REVISED STAFF REPORT AND RECOMMENDATION TO THE DESIGN COMMISSION

CASE FILE: LU 15-276553 DZM
PC # 15-238905
Jupiter Hotel Expansion
REVIEW BY: Design Commission
WHEN: April 21, 2016 at 1:30 PM
WHERE: 1900 SW Fourth Ave., Room 2500A
Portland, OR 97201

Ground Floor Plan
Scale: 3/32" = 1'-0"

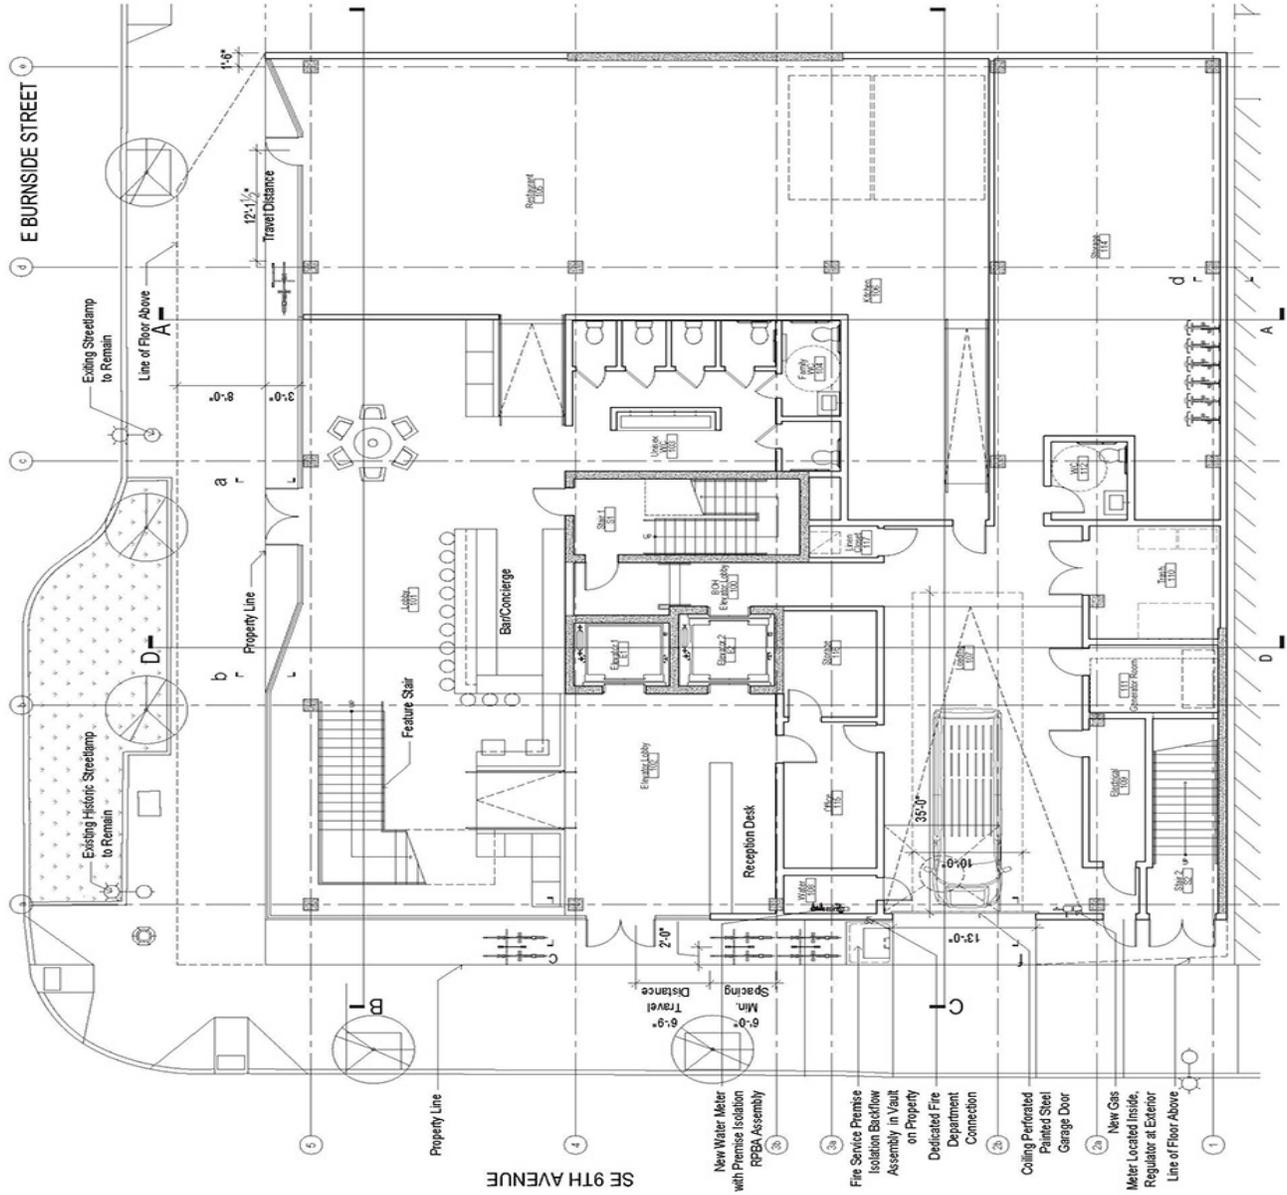
Findings: The 43,000 SF of hotel, event space and retail requires one large Type A (35’ long x 10’ wide x 13’ vertical clearance) loading space on site. The project originally proposed two small Type B (18’ long x 9’ wide x 10’ vertical clearance), however the loading analysis provided revealed that larger trucks were servicing the adjacent hotel and others in the area and Transportation was not supportive of the request. The proposal was thus revised for the larger Type A space, however, included a reduction to the height. As indicated in Figure 16 of the Loading Analysis, dated 2/4/16, the tallest truck servicing the adjacent hotel and others in the area, is 12’ in height. Transportation has reviewed the loading study and findings and concurs that 12’ vertical clearance is adequate for the Type A loading spaces and is therefore consistent with the purpose of the standard.

This modification to a reduced loading space height will better meet Central City Fundamental Design Guidelines C1-1 (Integrate parking) and C5 (Design for Coherency) in that a smaller loading bay door is more complementary to the

1. *Loading* – To reduce the 13’ vertical clearance to 12’ for the required for the one large loading space provided on site (Section 33.266.310).

Roof Plan
Scale: 1/8" = 1'-0"

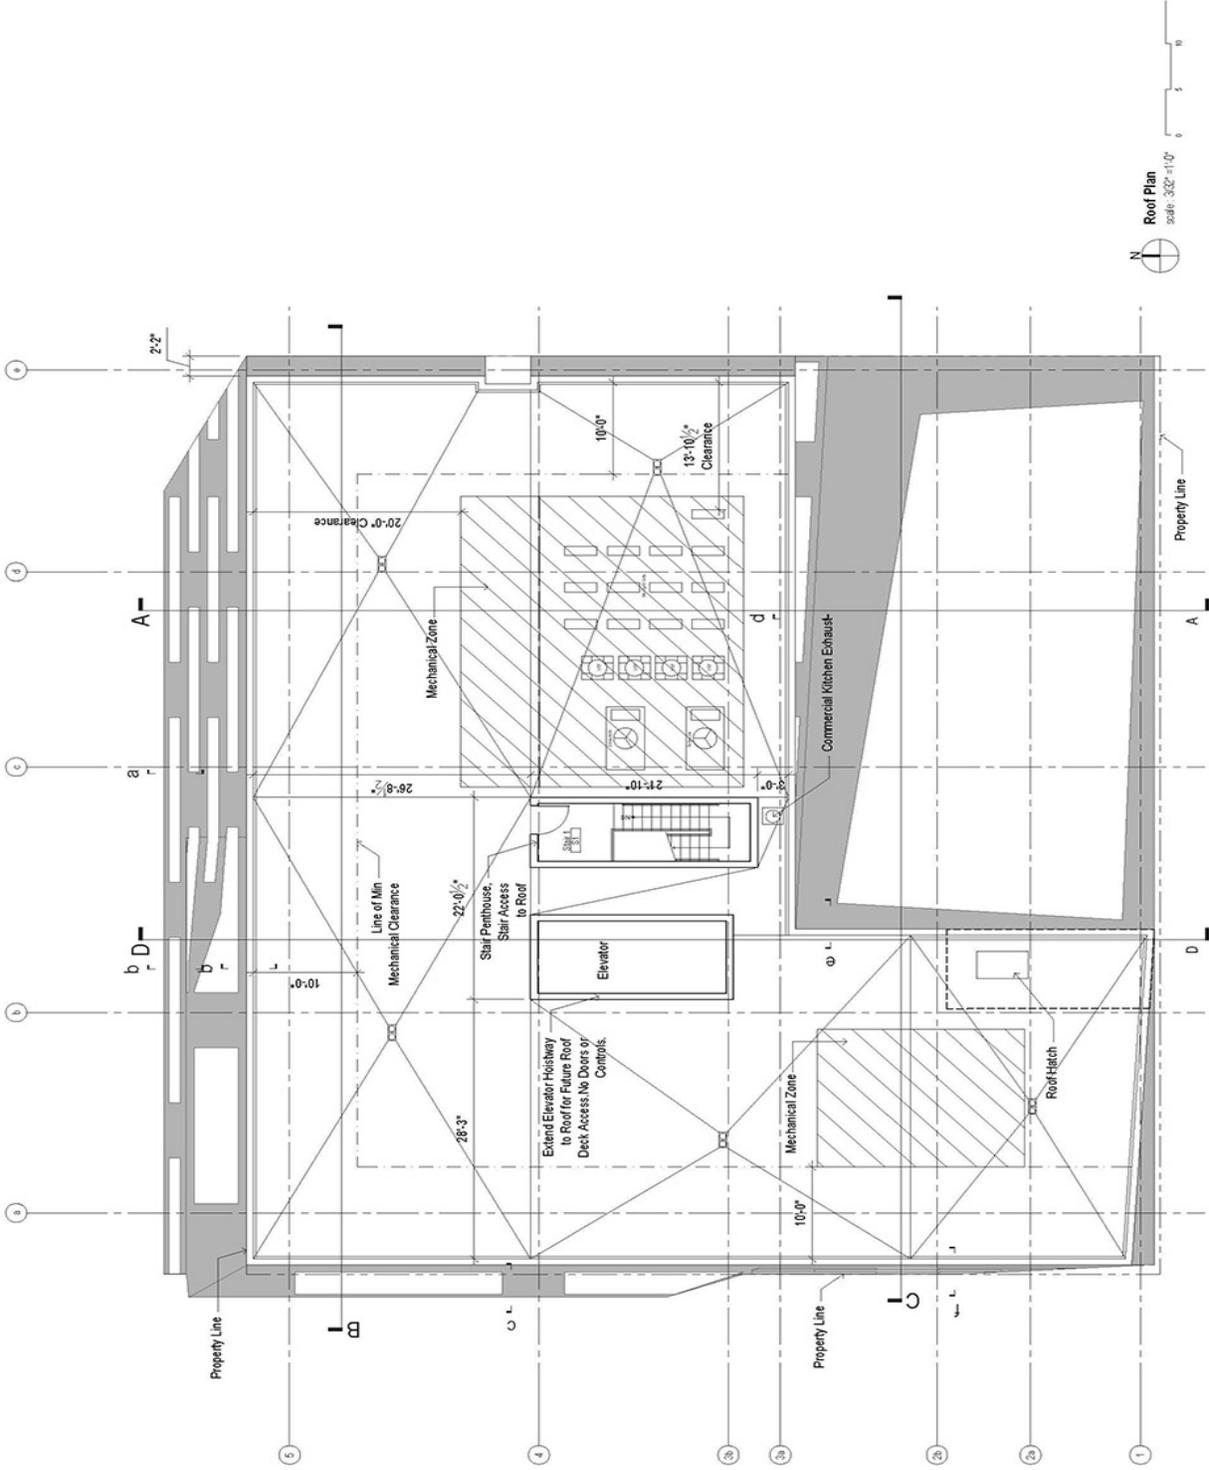
Findings: The rooftop includes a 13'-9" tall elevator overrun, 7'-9" tall stair enclosure and a series of mechanical units that range from 3'-8" to 5'-5" in height. The elevator and stair enclosures will be clad in metal to match the metal elsewhere on the building and will be centrally located in the middle of the roof. The mechanical unit zone will be setback 30' from Burnside, 14' from the east roof edge and screened from 9th by the rooftop structures. The consolidation of the units will unify their presence from elevated locations and the setback and lower profile will reduce the visibility from the street frontages. A future roof deck that would take advantage of the vast views of the downtown area, Willamette River, West Hills, Mt. Tabor and Mt. Hood is also being considered. Any exterior alterations necessary to accommodate such addition would be reviewed in a future design review. The second floor is partially occupied by a roof garden that will be both an inviting amenity to the occupants as well as an opportunity to incorporate additional stormwater management tools on site. *These guidelines have been met.*

South Exterior Elevation
Scale: 3/32"=1'-0"

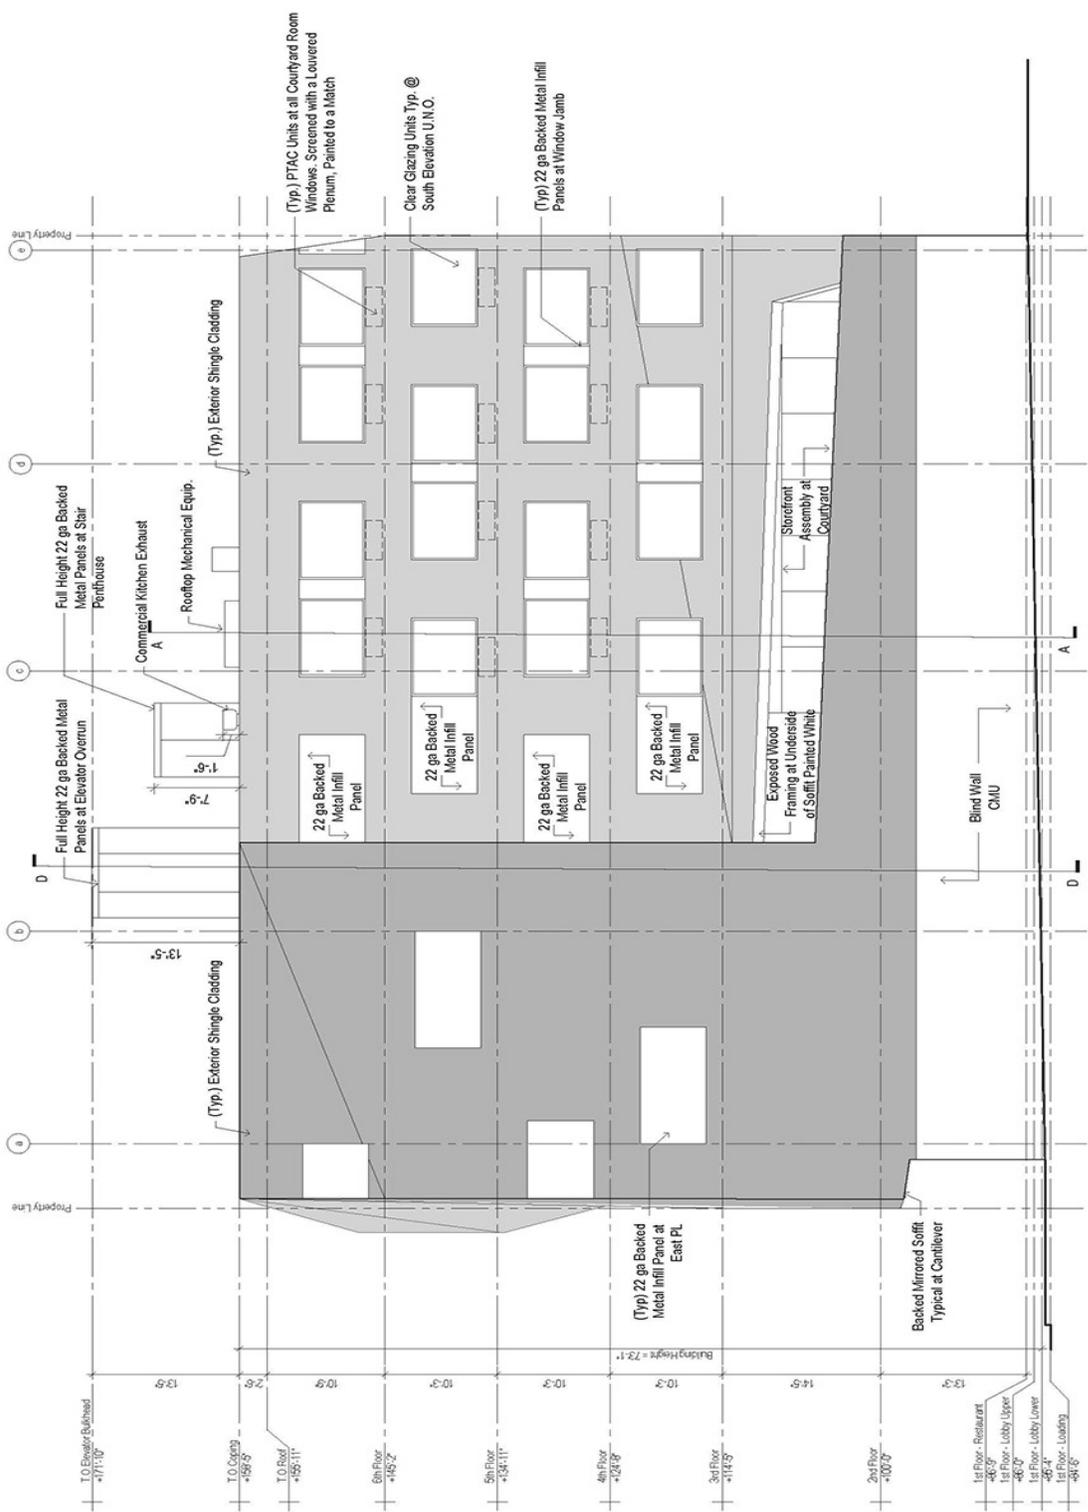
- The south end wall has been revised to reflect the design presented at the March 24th hearing. The art murals are no longer proposed and the fenestrations from the street facades now extend to both end walls for a permanent architectural solution that results in a coherent composition.
